9409522 Symétrique au plan/Symmetric of the plan

E	Change of holes Ø9 by M8 for the fixation of protections rails. Add chamfer 5.	24/02/2021	DGO	EAP 85484 EAP 83830
D	Add 5 holes Ø 9	29/10/2014	CB	EAP 29545
C	Modif position hole Ø80	26/11/2012	DGL	EAP17963
B	Delete Ø9	06/02/2008	DG	EAP1922
A	Ajout de la découpe 180x10 / Addition of cutting 180x10	05/11/2007	DG	EAP1922
REV.	DESCRIPTION	DATE	Modified by	ECR
 Tolérances générales Voir DMS : 080		 MARQUAGE PIECE P/N + Rev		
Matière	S235J2	Masse (Kg)	Format	Ech.
Protection	Brut / Raw	64.3620	A3	1:10
TOLE INFÉRIEURE GAUCHE LEFT INFERIOR SHEET				
9409466		E02	1/3	
P/N		Rev.	Folio

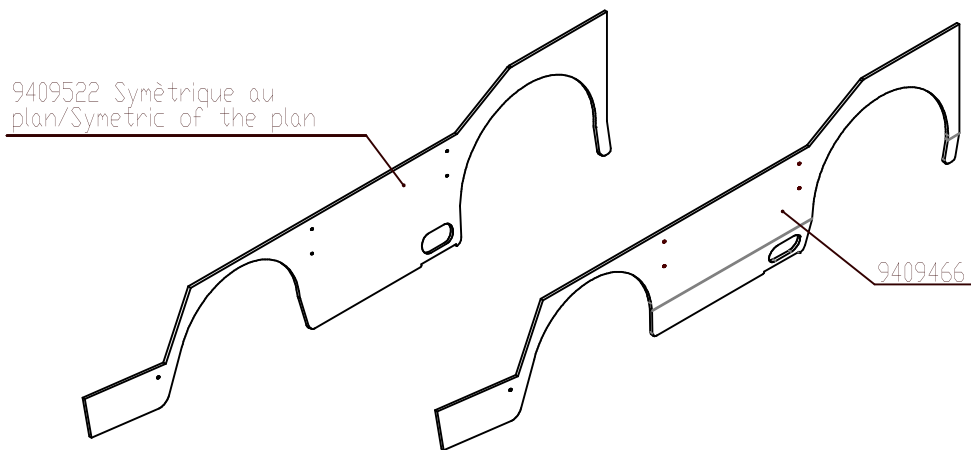
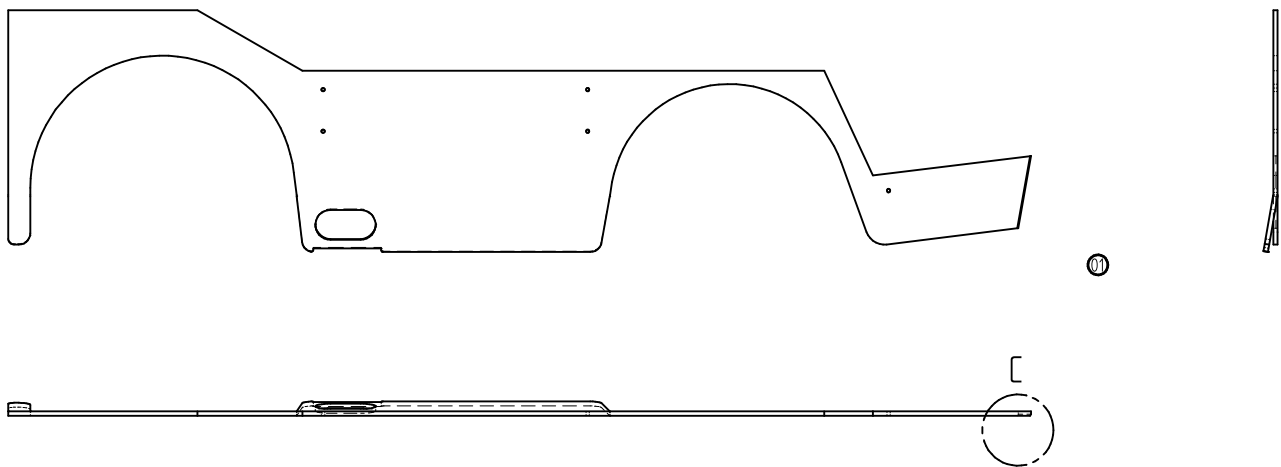
02 ZM/22/00288 - ÚPRAVA ÚKOSU NA 10x30°

01 ZM/22/00117 - NA POŽADAVEK TECHNOLOGA UPRAVENO DXF, 29.3.2022, BALARYNOVÁ

9409522

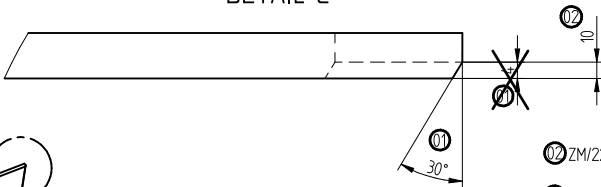
- 02 ZM/22/00288 - ÚPRAVA ÚKOSU NA 10x30°
17.6.2022 KAHÁNEK
01 ZM/22/00117 - NA POŽADAVEK TECHNOLOGA UPRAVENO DXF, 29.3.2022, BALARYNOVÁ

E	Change of holes Ø7 by Ø6 for the position of protection rails. Add Chamfer 3.	24/02/2021	DGD	EAP 25454 EAP 23830
D	Add 5 holes Ø 9	29/10/2014	CB	EAP 29545
C	Modif position hole Ø80	26/11/2012	DGL	EAP17963
B	Delete Ø9	06/02/2008	BC	EAP1922
A	Ajout de la découpe 180x10/ Addition of cutting 180x10	05/11/2007	BC	EAP1922
REV.	DESCRIPTION	DATE	Modified by	ECR
 Tolérances générales Voir DMS : 080		 #		MARQUE PIÈCE R/N + Rev
Matière	S235J2	Masse (Kg)	Format	Ech.
Protection	Brut / Raw	64,3620	A3	1:10
TOLE INFERIEURE GAUCHE LEFT INFERIOR SHEET				9409466 7/11
				E02 Rev.
				2/3 E02
